PRODUCT CHANGE NOTIFICATION

Select Bourns® Metal Oxide Varistors *Part Number and Lead Style Change*

MOV Naming Rules

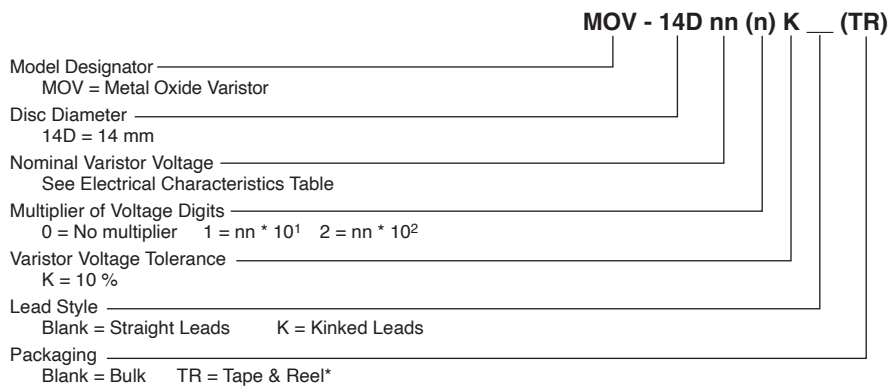
Under the new MOV naming scheme, MOV-14Dnn(n)K, with one “K” at the end, represents the straight leads and MOV-14Dnn(n)KK, with two “KK” at the end, represents kinked leads. Please refer to the complete MOV naming rules provided below for more details.
